Locomotive Workshop, Bays 5-15

*State Significant
Development Modification
Assessment
(SSD 8449 MOD 4)*

February 2020

Figure 3 | Proposed ground floor changes to Bays 5 -13

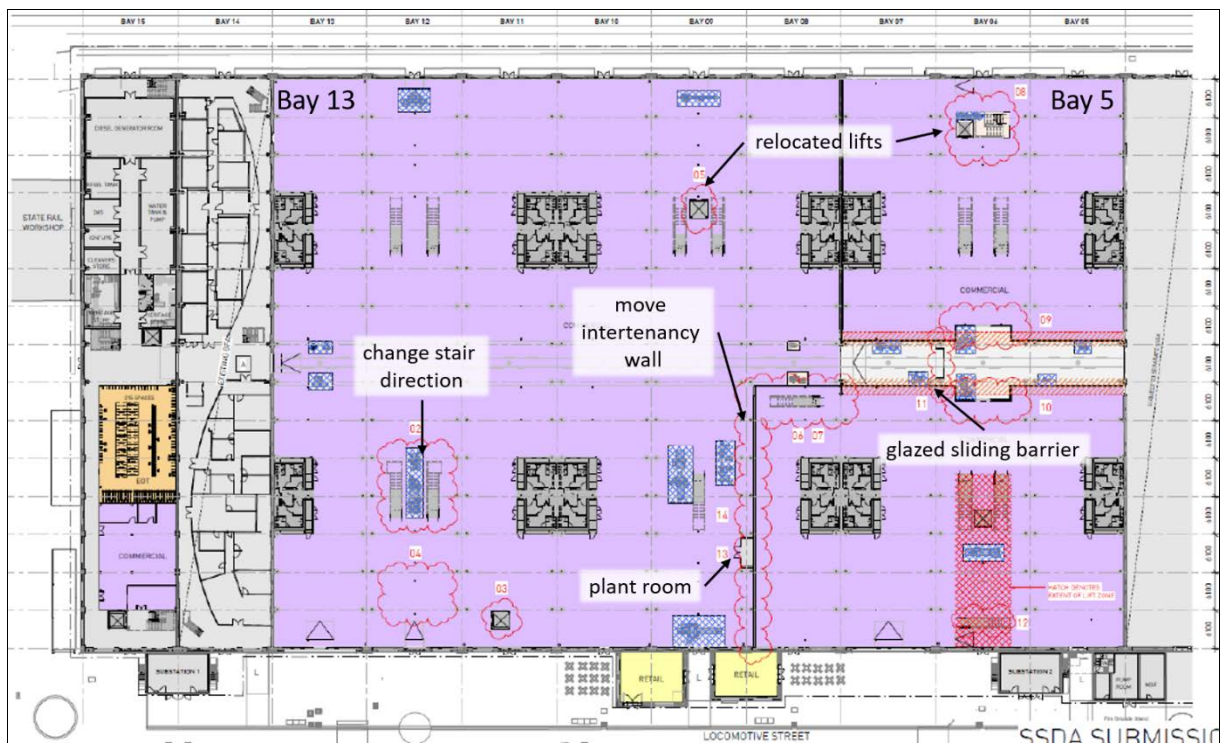
The proposal includes new and reconfigured stairs, lifts and access bridges on level 1 (**Figure 3**). The Applicant advises the changes:

- meet the BCA requirements for emergency egress and the additional stairs and access bridges will ensure that occupants on level 1 are within a compliant distance to a point of choice for egress in an emergency
- improves internal circulation and meets tenant requirements.

The Department supports these modifications, as well as the other changes to stairs and lifts as:

- it results in an internal layout that complies with the requirements of the BCA
- the access bridges have been designed with a slim profile to minimise structural requirements (**Figures 10 and 11**) and are a minor addition to Level 1

- changes to stairs and lifts are minor changes to the approved layout and have no physical impacts to heritage fabric
- the bridges will improve circulation across Level 1.

Figure 5 | Proposed location of the sliding glazed barrier on gridline 8

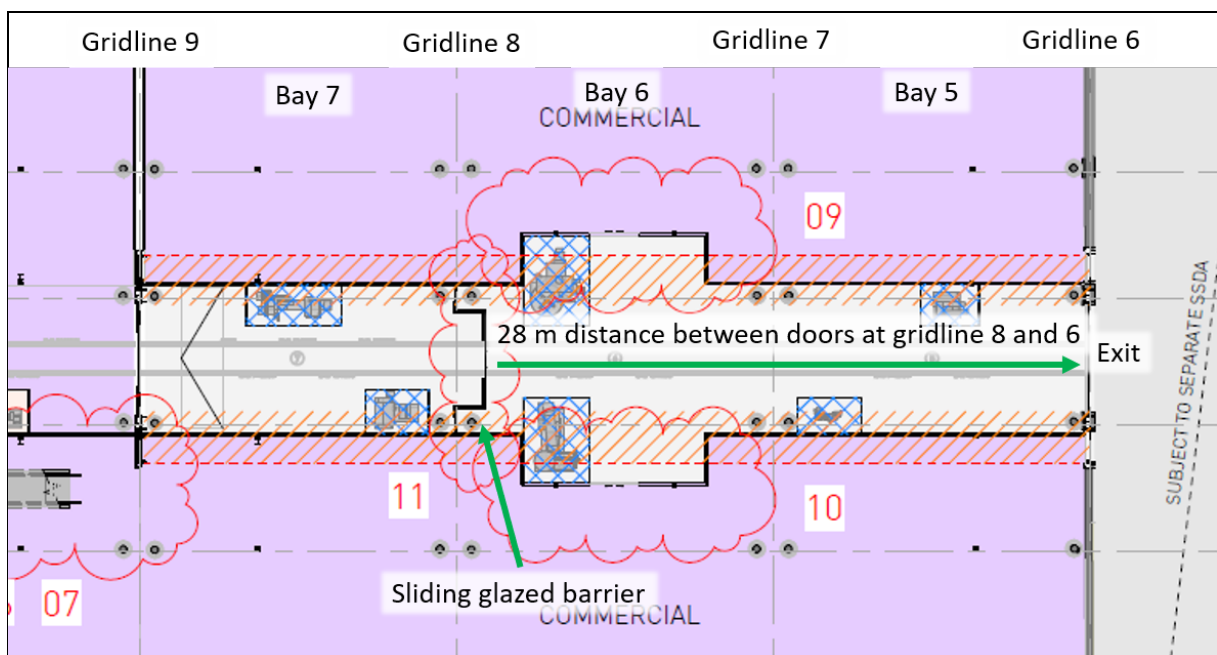
- architectural drawings for the new sliding barrier, including the door specifications, structure and materials, noting that the sliding door is located in the central spine, an area intended to be kept open to provide views through the building
- clarification on whether the access bridge in Bay 10 central is to be reconfigured or is an additional bridge.

- additional justification and detail to understand the new sliding barrier, including the proximity of the proposed door to the approved sliding door at gridline 9 and potential impact to views along the central spine zone
- provide further detail of the relocated intertenancy wall, including the interaction between the new wall and roof truss structure.

- the sliding glazed barrier in Bay 8, while allowing for visual continuity of sightlines along the central spine, will obstruct the openness of the corridor which is free from structures and restricts public access into the central spine
- the modification to comply with the BCA is unconvincing and Council recommends an alternative design solution be explored
- the change to the access bridge in Bay 10 central remains unclear.

- the documentation does not adequately demonstrate how it complies with BCA and fire engineering requirements
- it will provide another visual and physical barrier along the central spine zone, which was a critical corridor to the original functioning of the building
- it prevents public access to two significant moveable heritage items.

The Department has considered the location and design of the proposed sliding glazed barrier and considers it satisfactory in this instance as:

- the glazed barrier has a low height (1.2 m), will continue to allow for views along the central spine of the Locomotive Workshop (**Figure 7**) and it is visually less intrusive than options such as the creation of a corridor

- the barrier is critical to the fire safety strategy for the Locomotive Workshop, compliance with the BCA and to ensure the safety of members of the public

- the barrier will not have any significant physical impact to any heritage fabric and retains the original approved design of transparency and openness in the Locomotive Workshop while allowing for the adaptive reuse of the space

- the space between gridline 8 and 9 will be used as an entry to the tenancy in Bays 8-13 north and Bays 9-13 south. As per the Stage 2 Heritage Interpretation Plan, during guided tours on open days members of the public will have access to this space, as fire exits in tenancies will be available for use.

Figure 6 | Corridor option

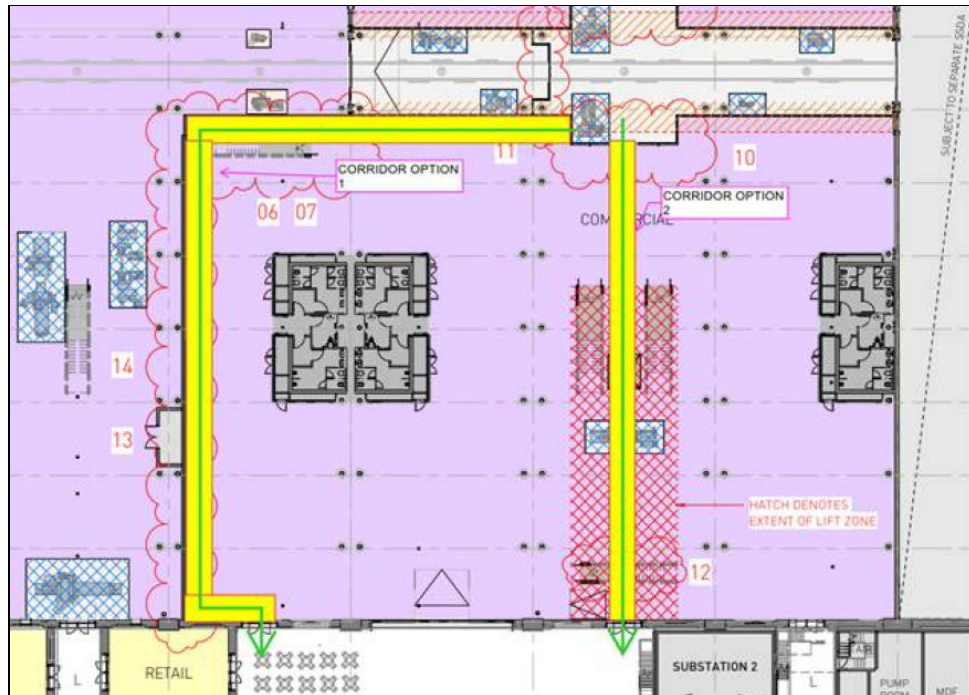
- to create a closed corridor through the tenancy in Bays 5, 6 and 7 which would terminate at an existing exit on the southern façade (**Figure 6**). This option was not pursued as it interrupts the design of the tenancy and creates a divided space which is inconsistent with the openness of the Locomotive Workshop
- the possibility of a removing the barrier, given the heritage significance of the Locomotive Workshop. This option was not pursued as the barrier is deemed to be critical for the fire safety strategy for the building.

Figure 8 | Proposed full height glazed wall in Bay 8

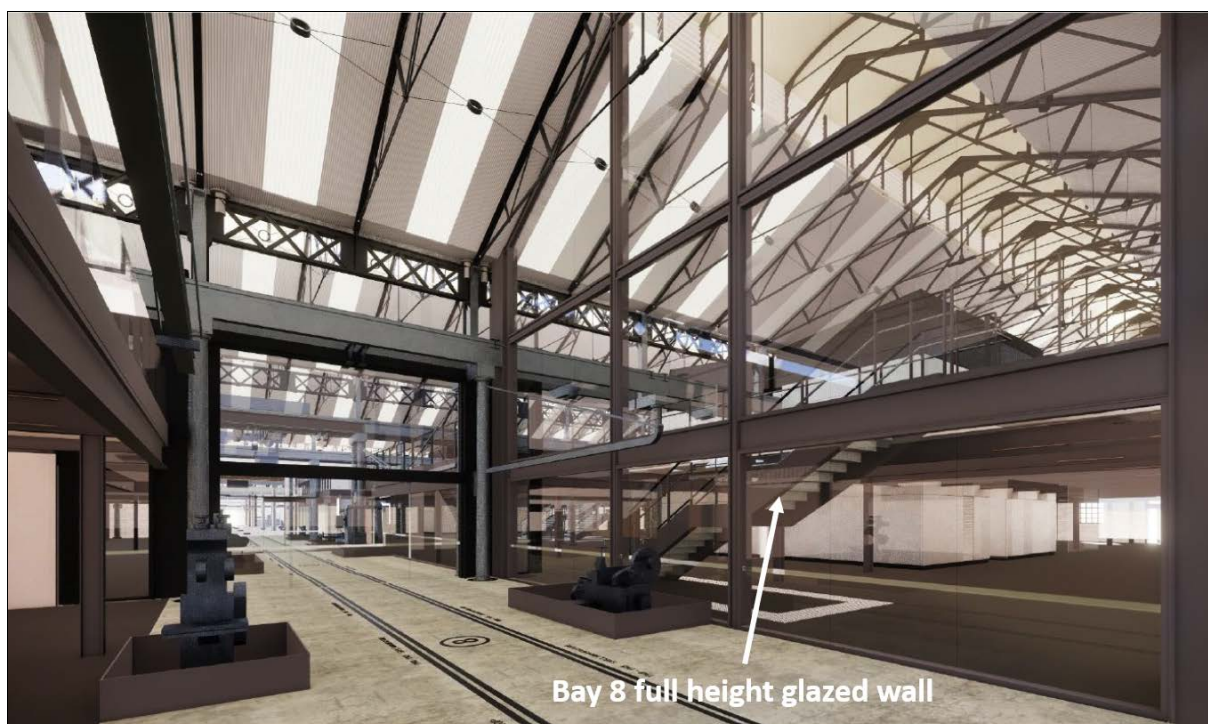
The Applicant seeks to relocate an intertenancy wall as a result of changes to tenancy configurations. The existing balustrade at level 1, facing the central spine is proposed to be replaced with a full height glazed wall (**Figure 8**).

- for physical and acoustic separation between tenancies
- to limit the spread of smoke between tenancies in the event of a fire (required under the fire engineering strategy for the base building).

Heritage NSW is satisfied with the additional detail provided of the amended intertenancy wall, including how it will interact with the significant roof truss and use of high-level glazing to enable views to the truncated roof trusses to be maintained.

- there are no physical impacts to significant heritage fabric and the wall is designed to be fully reversible, so all heritage elements can be protected and maintained
- glazing is provided at the top of the wall to enable views to the truncated roof trusses
- the relocated wall will not adversely impact the design intent of the internal fitout.

Figure 9 | Approved access bridges, level 1, Bays 5-13

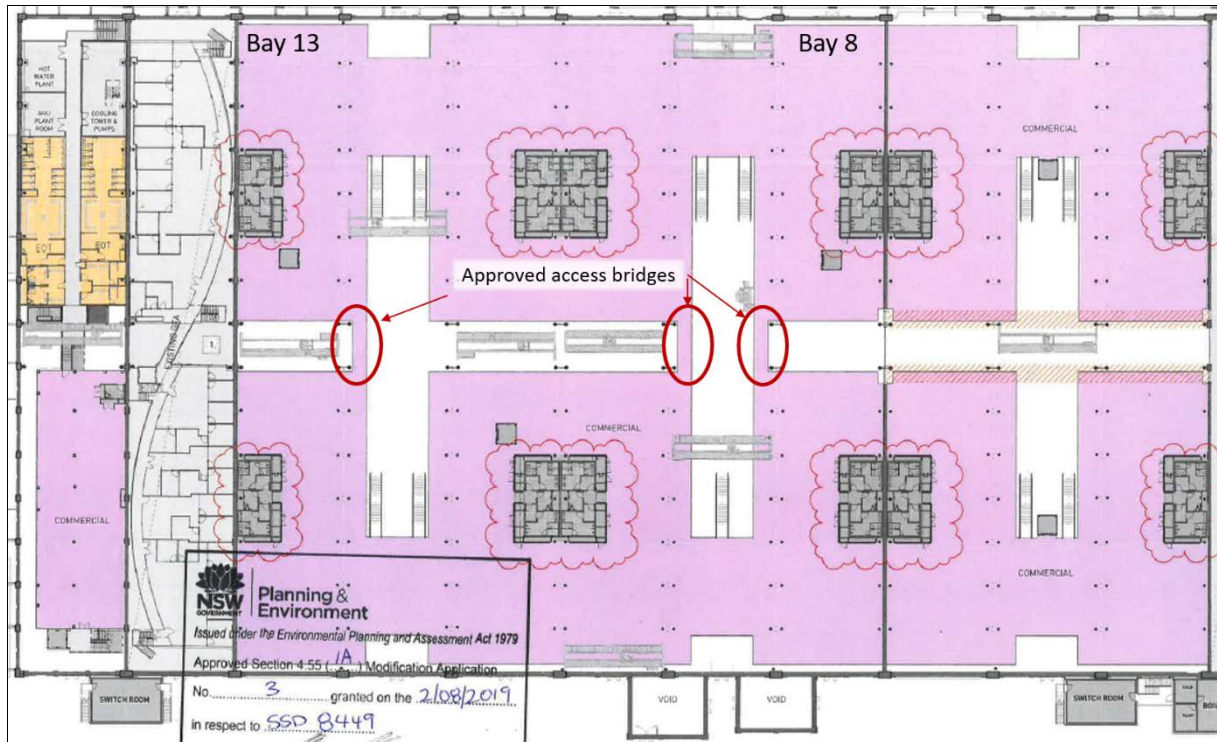
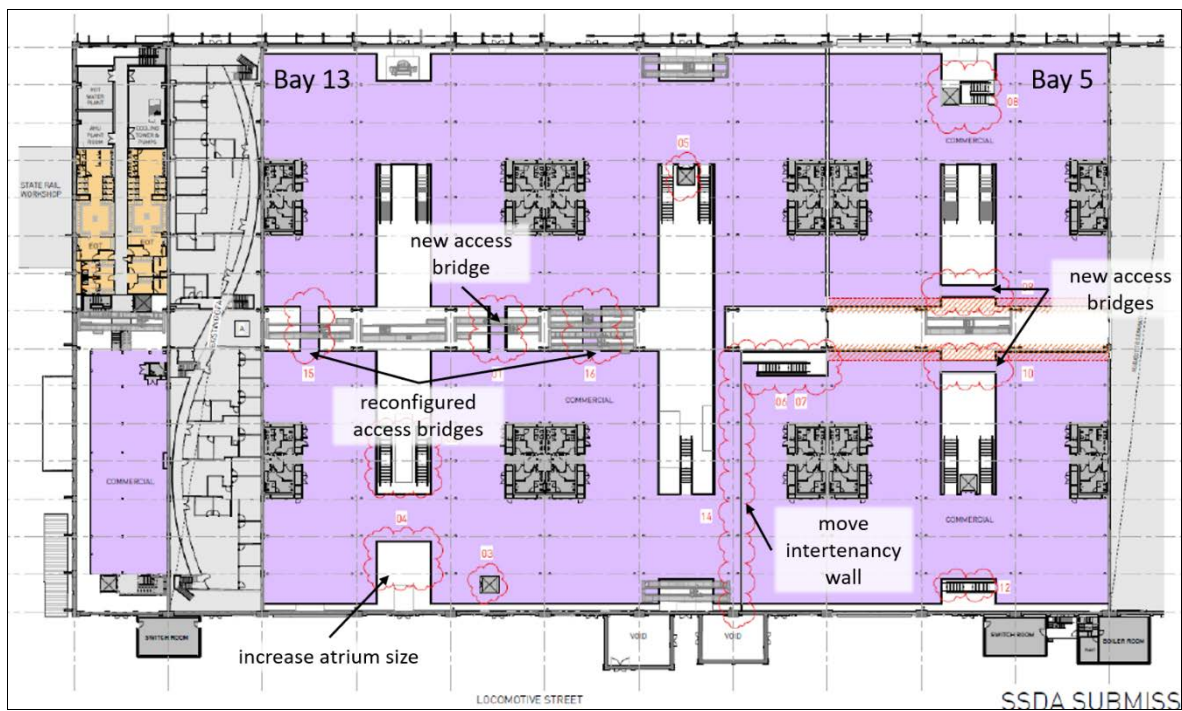
Council advised it was satisfied with all changes to stairs, lifts and access bridges, however noted the plans submitted with the RtS illustrate two access bridges in Bay 10 but it is unclear the location of the widened and centred access bridge outlined in the documentation.

The Department notes the most recent approved plan for Bays 5-15 (under MOD 3) provides for three access bridges on level 1, two in Bay 9 and one in Bay 12 (**Figure 9**). This proposal seeks approval to:

- reconfigure the Bay 9 bridge to the centre of Bay 10
- reconfigure the Bay 12 bridge to the centre of Bay 13
- add a new access bridge to the centre of Bay 11 (**Figure 4**).
